**Subject: Response to Portion of NRC Request for Additional Information Letter No. 375 Related to ESBWR Design Certification Application – Engineered Safety Systems – RAI Number 6.2-140 S05**

**RAI Number 6.2-140 S05**

**NRC RAI 6.2-140 S05**

**Figure 6.2-140 S05-D6 Main Steam Line Break, 1DPV Failure (Bounding Case), PCCS Vent Fan, Volumetric Flow vs. Head (30 Days).**

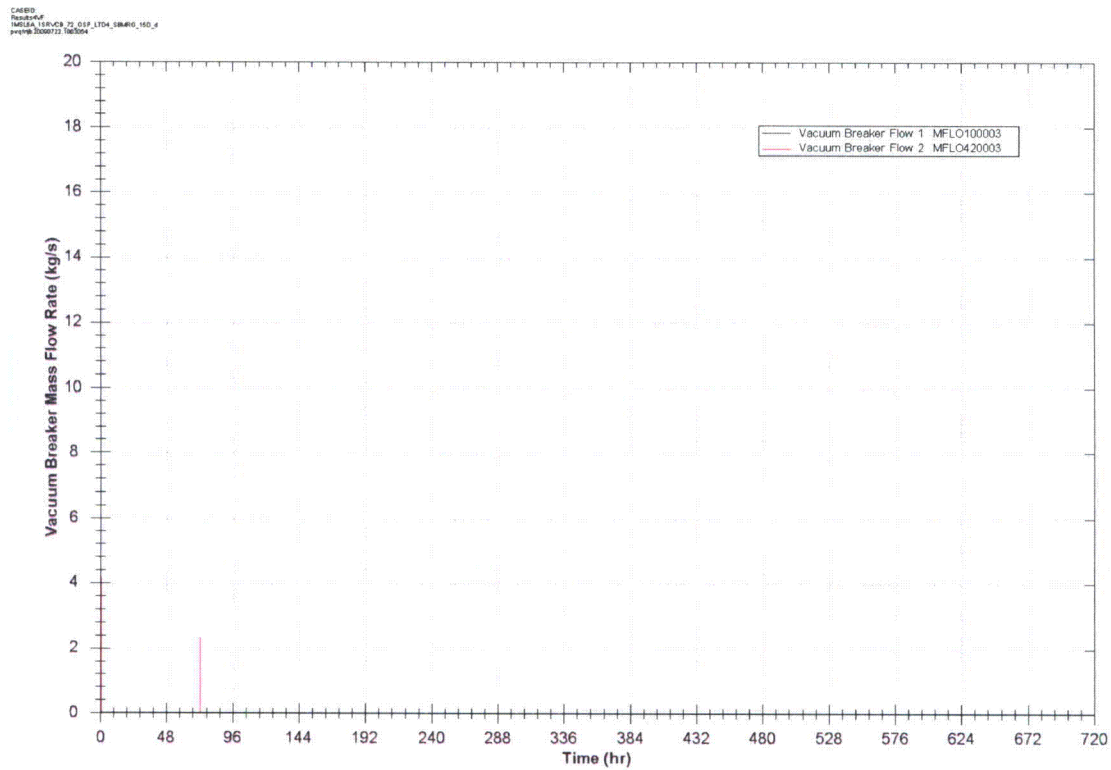
*D. ESBWR DCD Revision 6 Table 6.2-49 lists the minimum DGR fan performance requirements. Confirm that the DGR fan performance used in the containment analysis is bounded by the values listed in Table 6.2-49.*

**D:** To provide additional assurance that the fan performance is bounding, a sixth data point (at 1,570 CFM) will be added to DCD Tier 2, Table 6.2-49. The sixth data point provides enough data to cover the range of fan performance and bounds the TRACG data points shown in Figure 6.2-140S05-D6 below. Please see attached markups.

Figure 6.2-140S05-1 DW Pressure as a Function of PCC Vent Fan Submergence

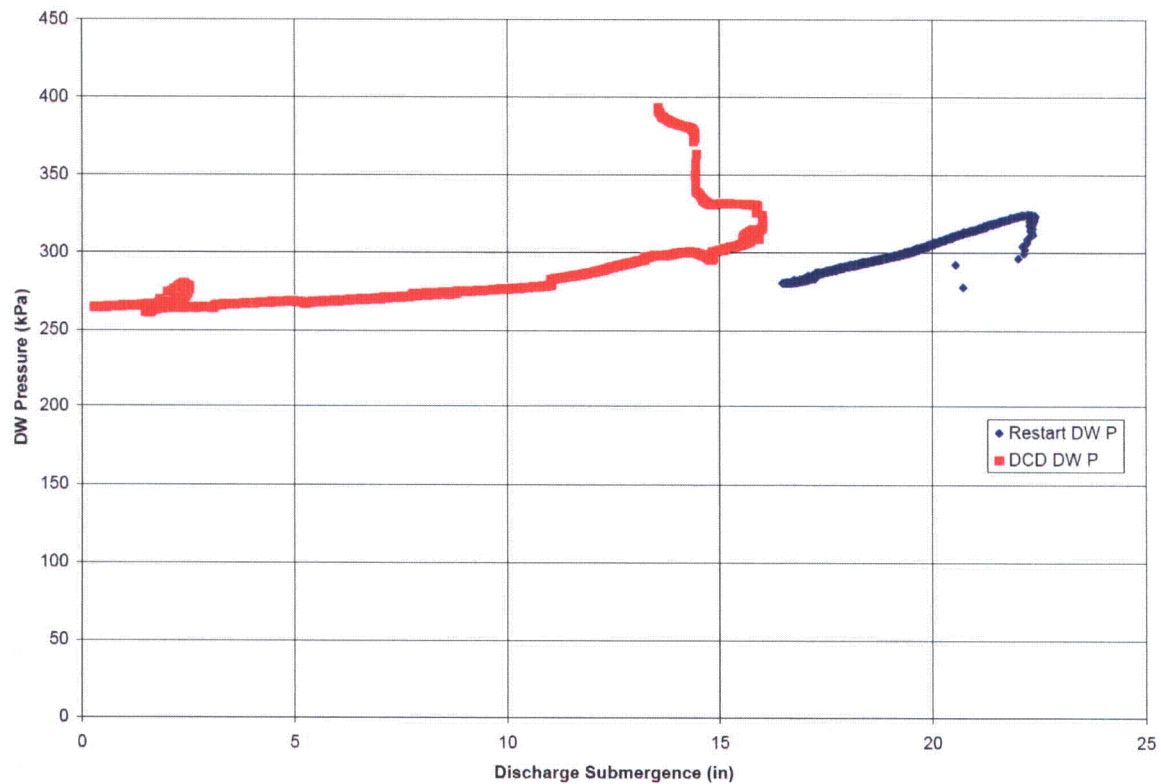
*C. ESBWR DCD Revision 6 states that "The vent fan discharge line is  $> 0.22$  m (9 in) and  $< 0.25$  m (10 in) below the top of the drain pan lip." Confirm that the DGR fan discharge line would stay submerged during the 30 day analysis.*

The TRACG analysis presented in ESBWR DCD Rev. 6 for the post-72 hour scenario does not maintain a 10 inch submergence of the vent fan discharge lines. However, a sensitivity study on the effect of the submergence was performed. The difference in PCC vent fan discharge elevation and GDCS pool level is seen to decrease over time as shown in Figure 6.2-140 S05-C5 below. However, the GDCS pool level illustrated in Figure 6.2-140 S05-C5 also confirms that the vent fan discharge does not become uncovered. The fan outlet is set in TRACG to a constant elevation of 20.91 m (referenced to Vessel Zero.) From the figure, the GDCS pool level in Ring 7, corresponding to the 4 vent fan pool, appears to reach a final level of 20.92 m. However, due to the fact that the discharge line is very close to being uncovered, an analytical DW pressure adder was developed as a safety margin.

Similar to the technique described in paragraph B above, an adder of 15 kPa (2.2 psi) is applied to the TRACG DW pressure response values as reported in ESBWR DCD Rev. 6. The basis for the additional pressure comes from a study conducted to gauge the effect of submergence of the discharge outlet on DW pressure. Shown in Figure 6.2-140S05-1 below, the DW pressure is seen to increase with increased submergence. The vertical section around 14 inches of submergence occurs early in vent fan operation and can be ignored. An adjustment factor is determined, considering submergence and decay heat as primary contributors to DW pressure. The DW pressure at the end of the increased submergence test case was 281 kPa; that results in a difference from the base case at the same time of ~12kPa. The submergence effect is then calculated as being 12 kPa divided by the difference in submergence of 10.5 inches, or 1.14 kPa/inch submergence. The stated submergence should be held at 10 inches, so multiplying the submergence effect value by 10 inches yields an adder to 11.4 kPa that is rounded up to 15 kPa. The effect of this adder plus the adder

Figure 6.2-140S05-2 ESBWR DW Pressure with Appropriate Safety Adders

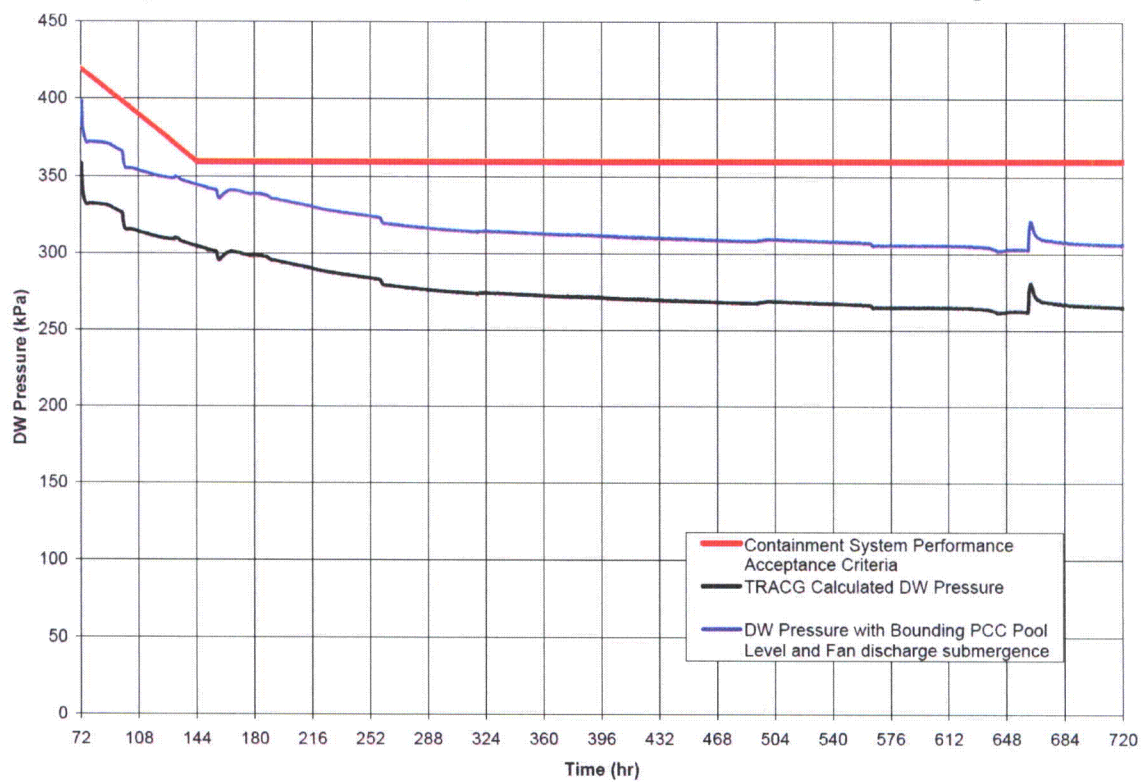
In the response to Supplement 4 of this RAI, GEH presented a plot showing the PCC pool level with respect to time (Figure 6.2-140 S04-B1). The analysis currently presented in ESBWR DCD Revision 6 contains a PCC pool refill control scheme that maintains the level in the pool closer to the top of the PCC tubes (DCD Rev. 6 Figure 6.2-14e10). Using the information from the TRACG calculation presented in Supplement 4 of RAI 6.2-140, a DW pressure adder of 25 kPa (3.6 psi) is applied to the DW Pressure curves reported in ESBWR DCD Rev. 6 to adjust the results considering the highest possible PCC pool level. The effect of this adder is shown in Figure 6.2-140S05-2 below.

described in paragraph B is shown in Figure 6.2-140S05-2 below. This figure will also be added to the DCD as indicated in the attached markups as Figure 6.2-14e13. To reduce redundancy, Figures 6.2-14e1 and 6.2-14e2 will be modified by removing the Analytical Pressure Limit Curve.

Figure 6.2-14e1. Drywell, Wetwell and RPV Pressures (720 hr)

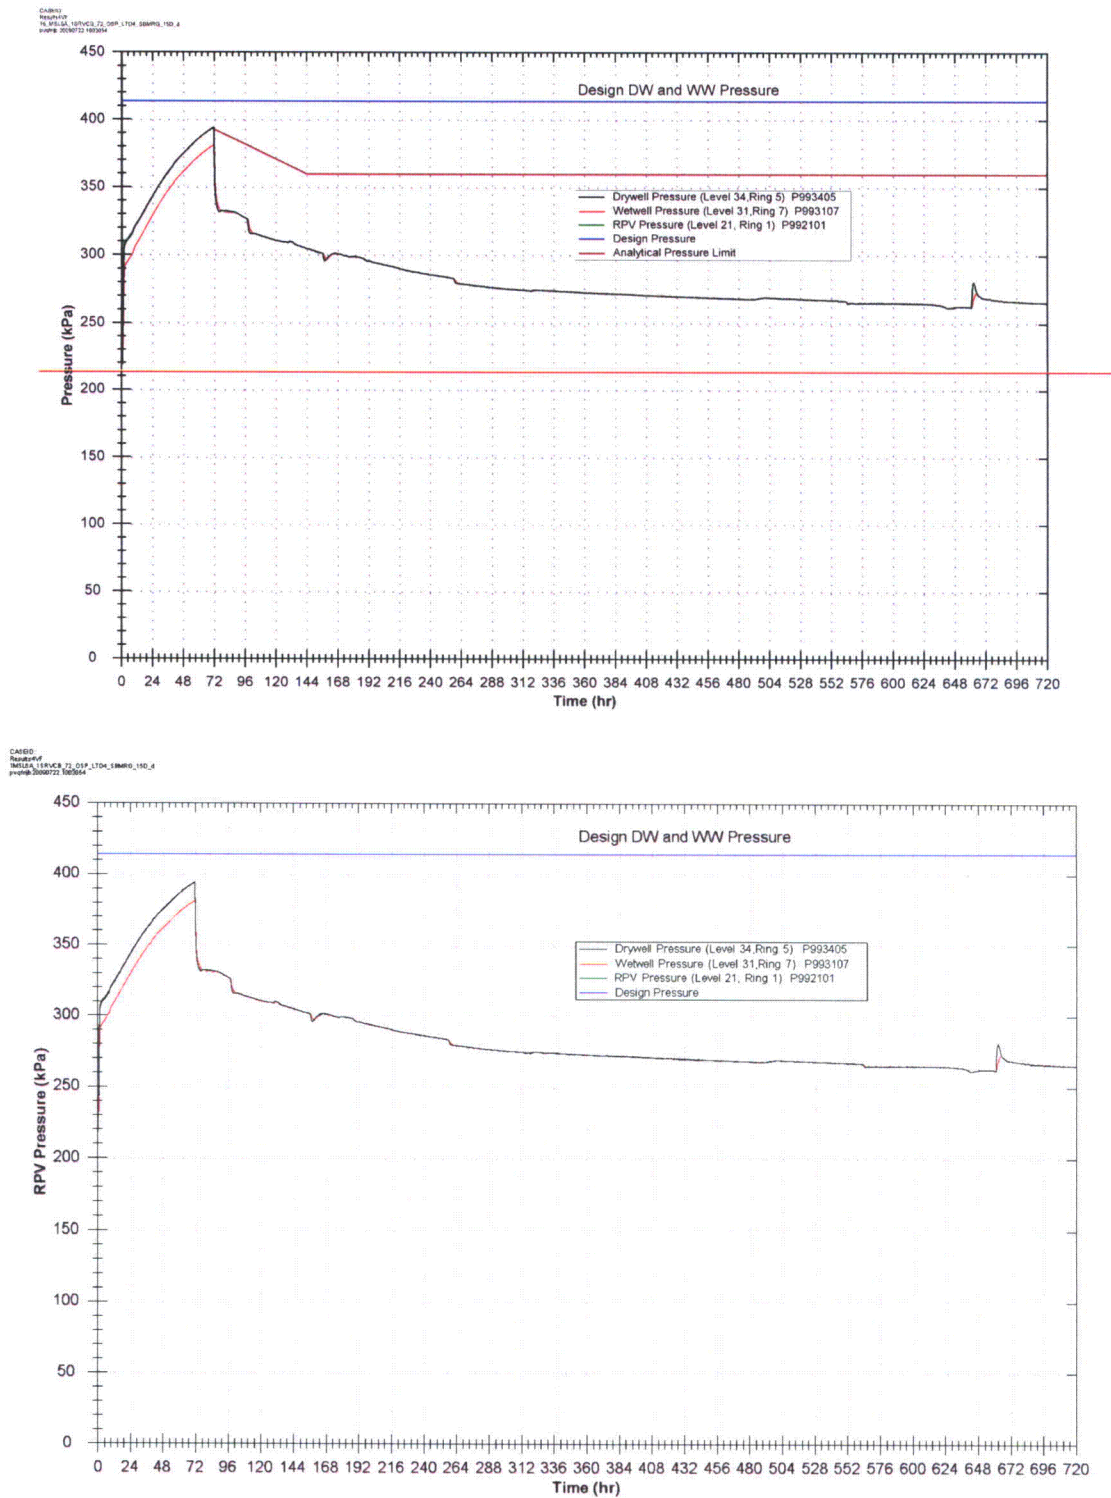
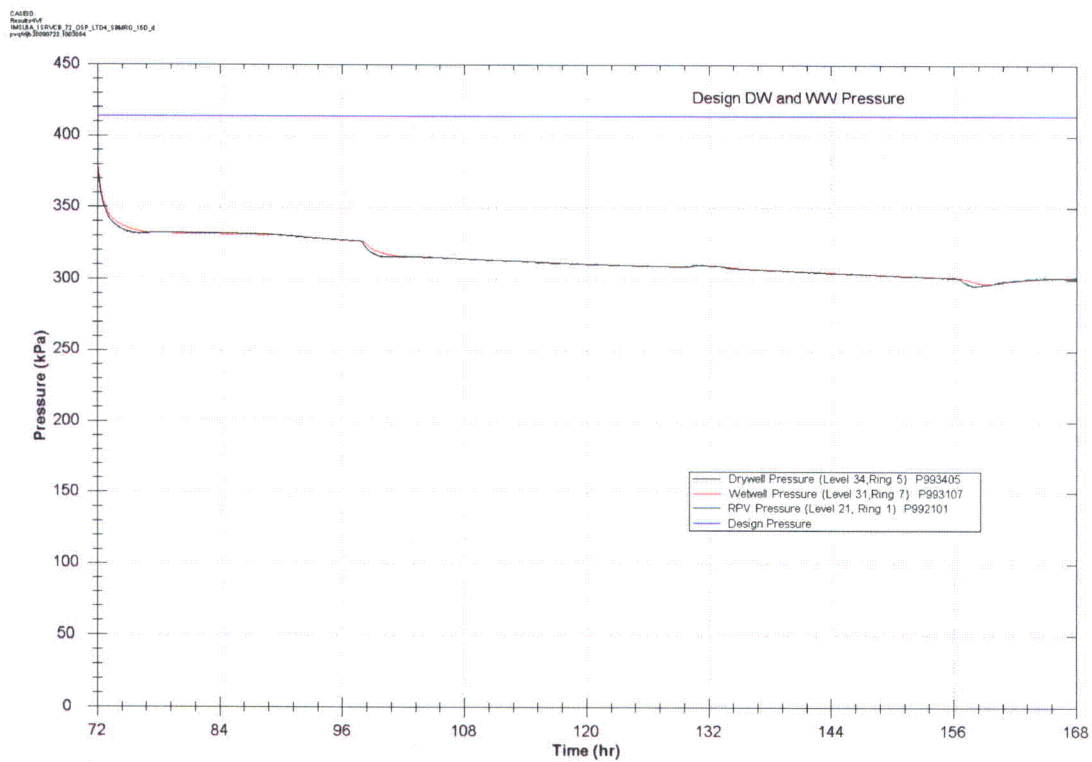
*E. ESBWR DCD Revision 6 Figure 6.2-14e1 shows curve of analytical pressure limit.*

- a. Explain the regulatory significance of this curve.*
- b. Explain how this curve would be used in ESBWR design.*
- c. Explain the relevance of this curve to ITAAC, if any.*
